Attachment A:

Summary and Recommendations on Issues of Additional Investigation at the Landsburg Mine site in Ravensdale

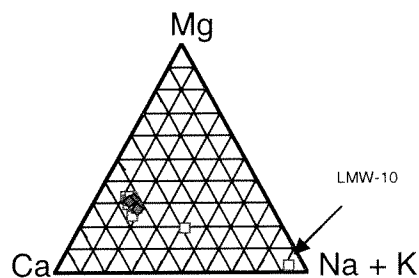
- 2) The well or wells may serve as early warning or sentinel well(s) in the possible event of a release from the source area in the trench. For example, in the event of an earthquake, the buried drums may potentially shift and rupture. Therefore, the deep well(s) may be monitored for contaminants to track contaminant transport.
- 3) The well(s) may be used for remediation or to extract mine water, thus lowering the water table and providing inward hydraulic gradients that will prevent breakout of potentially contaminated mine water.
- 4) There is evidence that deeper groundwater at the site is geochemically different from shallow groundwater based on major cation compositions. For example, the deep northern well LMW-10 that is screened at an elevation of 338.5 feet above sea level is richer in the alkalis Na + K and lower in Ca and Mg compared to other waters:

Data for the above graph was taken from the May 2004 groundwater analytical results. LMW-10 was a recently installed deep well. At present, we cannot preclude the high Na and K to be artifacts of the well installation process (from bentonite seal or from material in Portland cement used to fill the borehole beneath the well screen). Coupled with an upward hydraulic gradient at the discharge (portal) areas, this points to a complex flow system with upward groundwater flow from deeper levels. If there is contaminated water at these deep levels, based on the results of LMW-10, it may be expected that deeper waters may reach the shallow levels that affect groundwater use and surface water quality. Therefore, there is a need to identify the water quality emanating from the deeper region of the former mine.

Figure 1

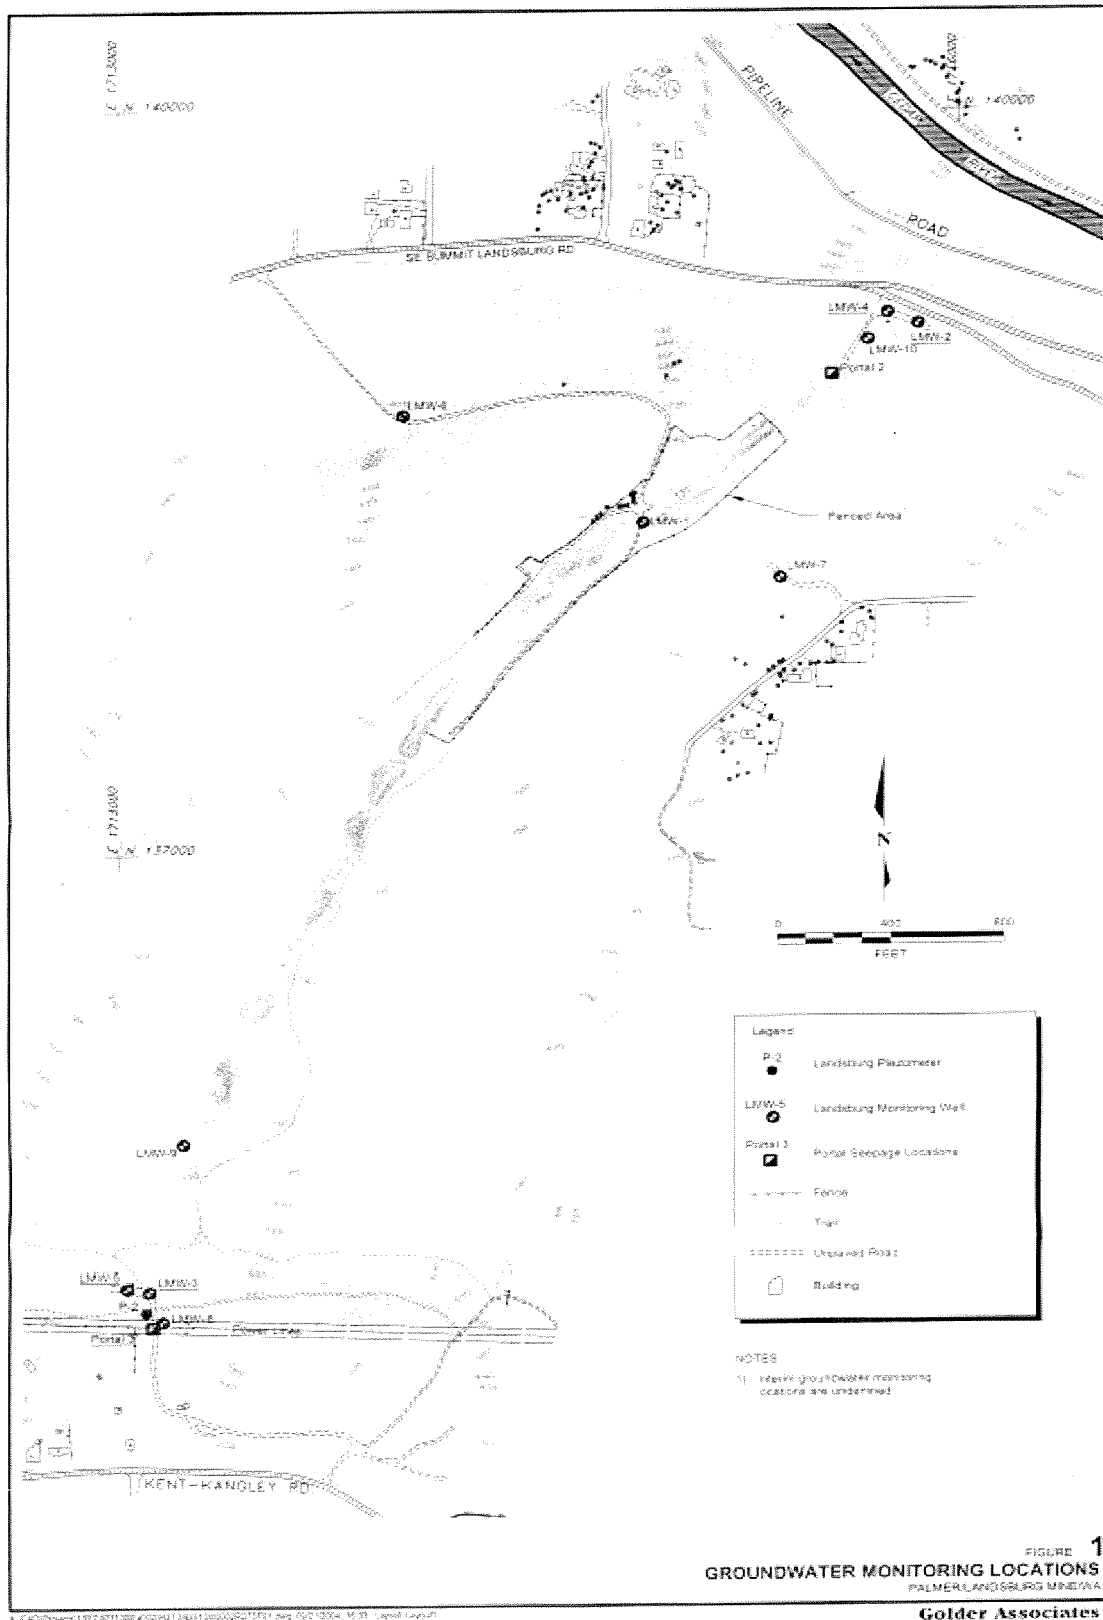
May 2000: Wells sampled were LMW-2, LMW-4, LMW-3, LMW-5, and Rogers Portal #3 seep water (see Figure 1 map). Results showed no significant change from 1996 Report of Investigation. Total dissolved solids, iron and manganese were the only compounds detected in excess of screening levels which are secondary maximum contaminant levels (SCMLs). SCMLs are not health based standards, but are based on aesthetic qualities of water. The high iron and manganese concentrations appear to be typical of coal mining regions.
